### DESIGN REVIEW COMMISSION AGENDA

Tuesday, December 19, 2023 – 5:00 P.M. Bartlett City Hall Annex Conference Room

Staff Comments

### Plan:

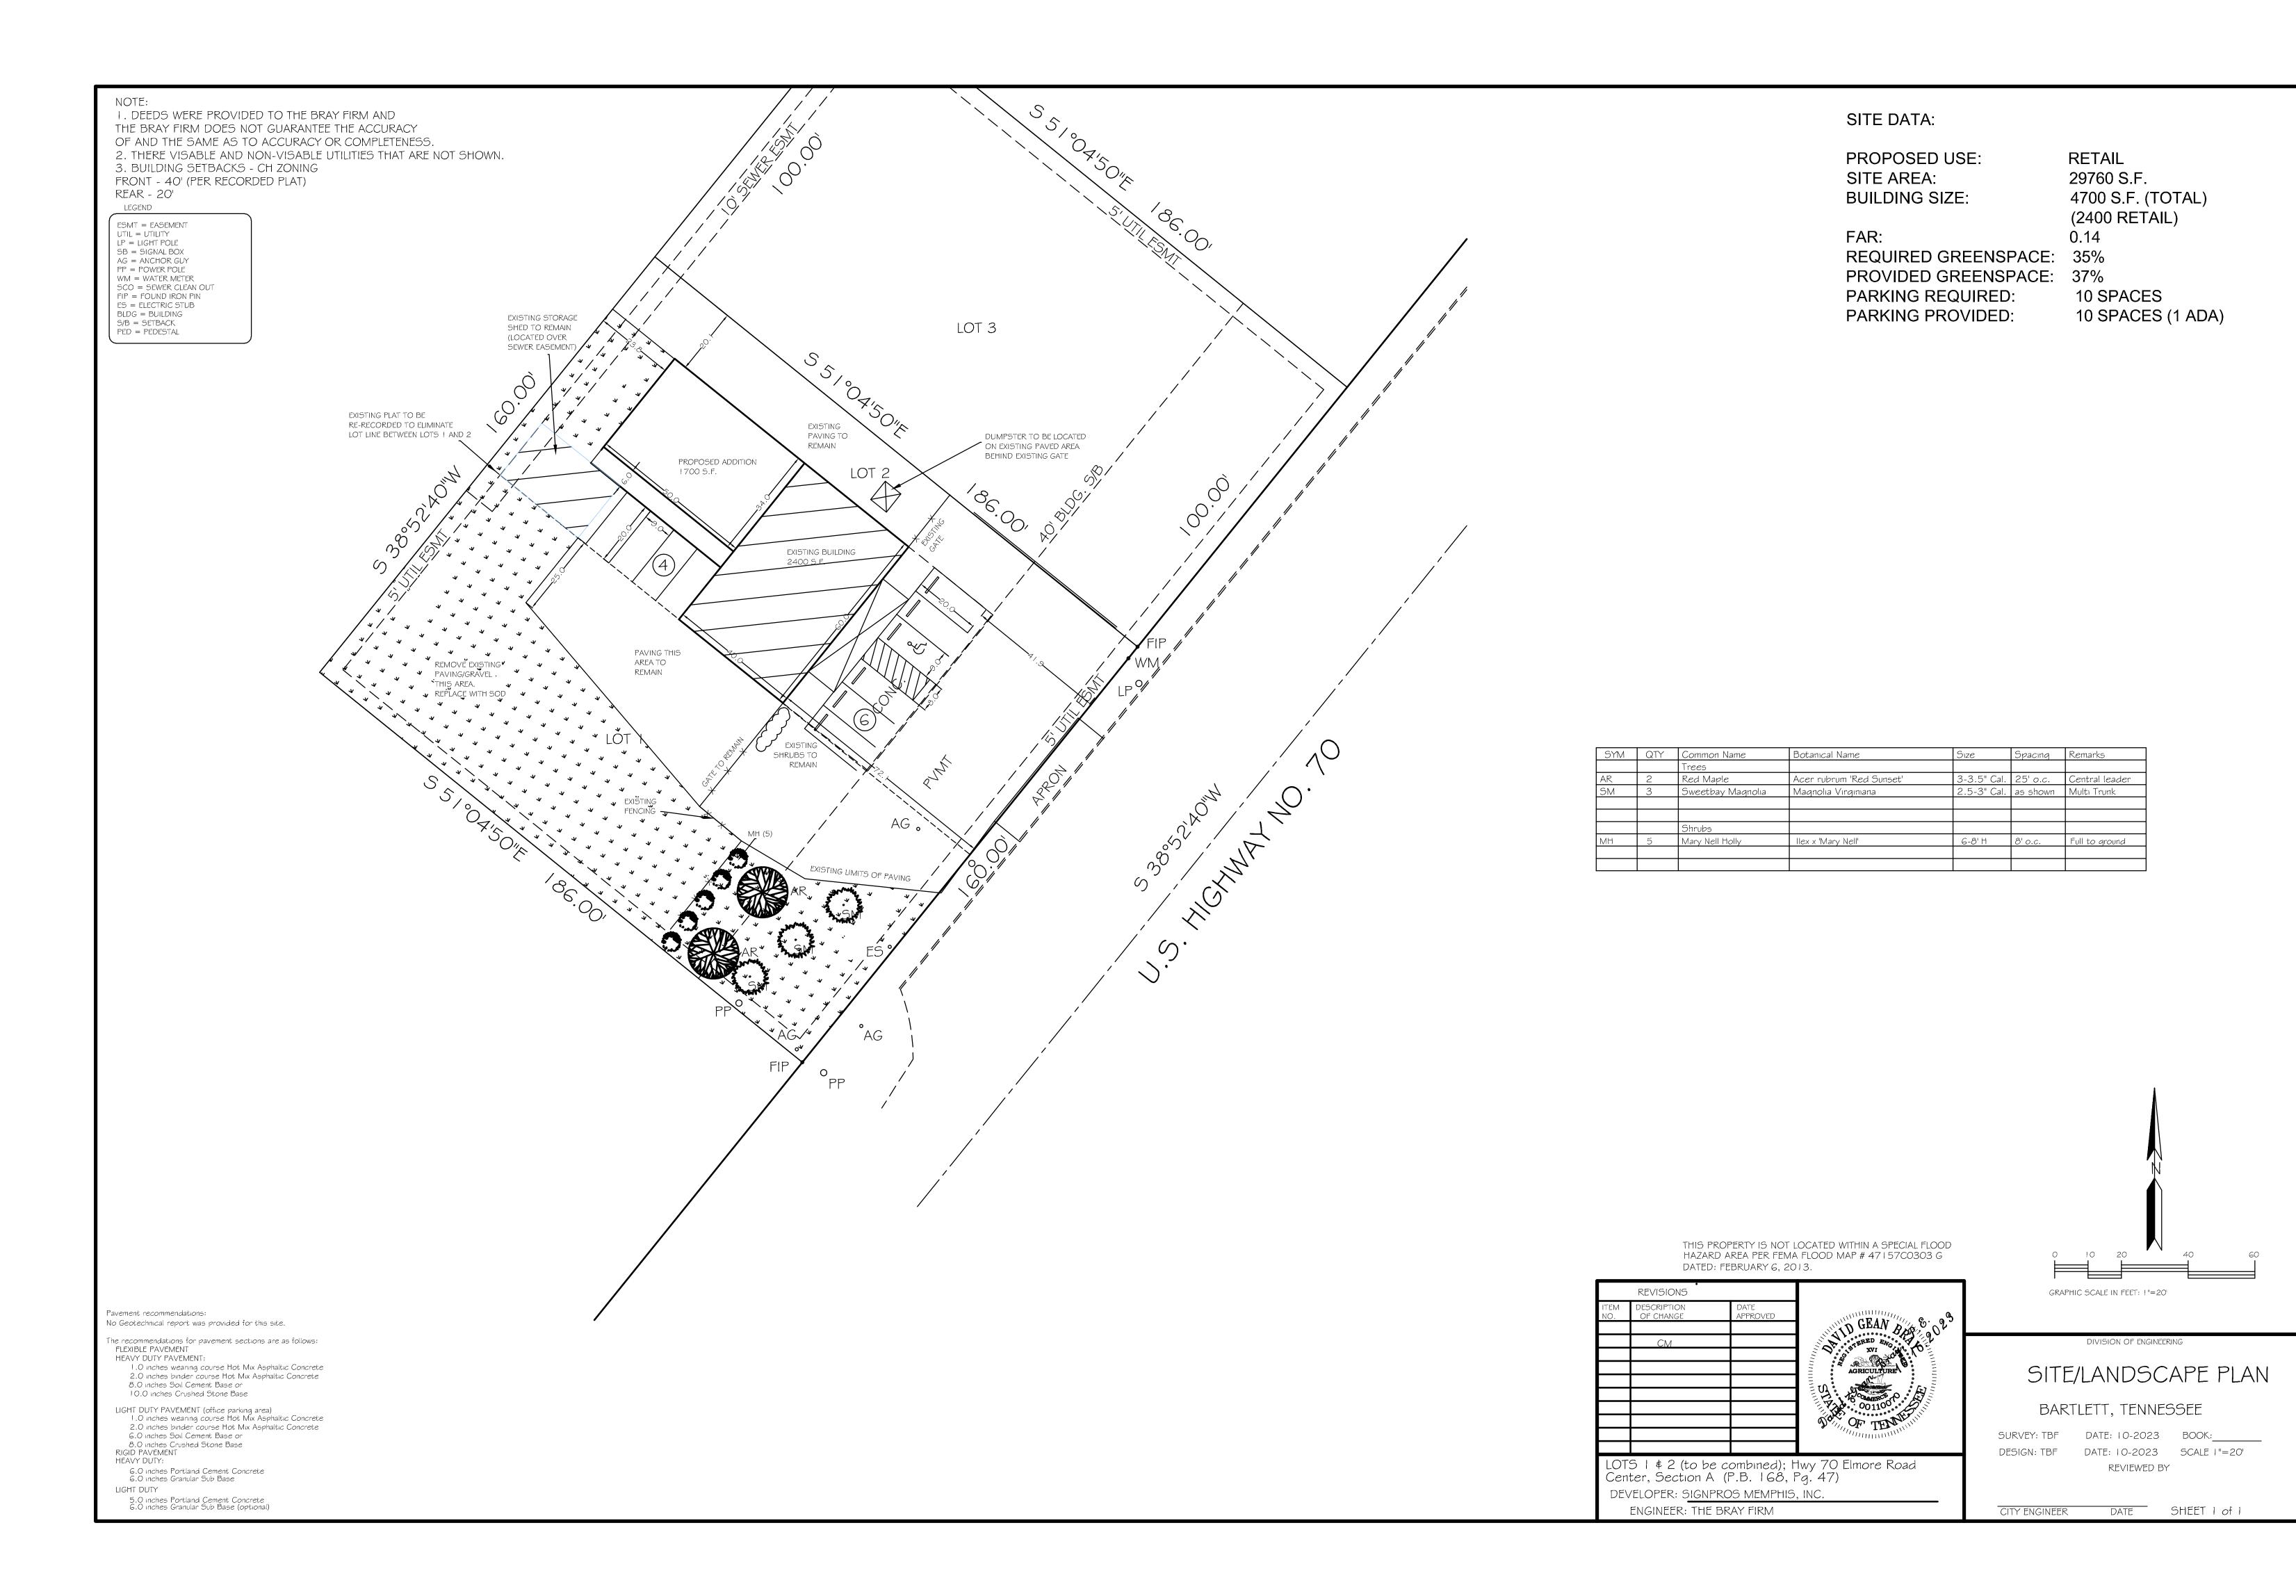
- 7. This site is Lot 3 of the recorded subdivision for Corner Shops of Highway 70 and has a platted ingress/egress easement with driveway location shown. This plan shows the driveway connection in an alternate location, this will require TDOT approval.
- 8. If alternate driveway location is acceptable, the ingress/egress easement will need to be abandoned and rerecorded in the new location. This will require a new easement document, which all property owners will need to sign.
- 9. The driveway on HWY 70 will require a TDOT permit, a construction detail shall be added to the plans.
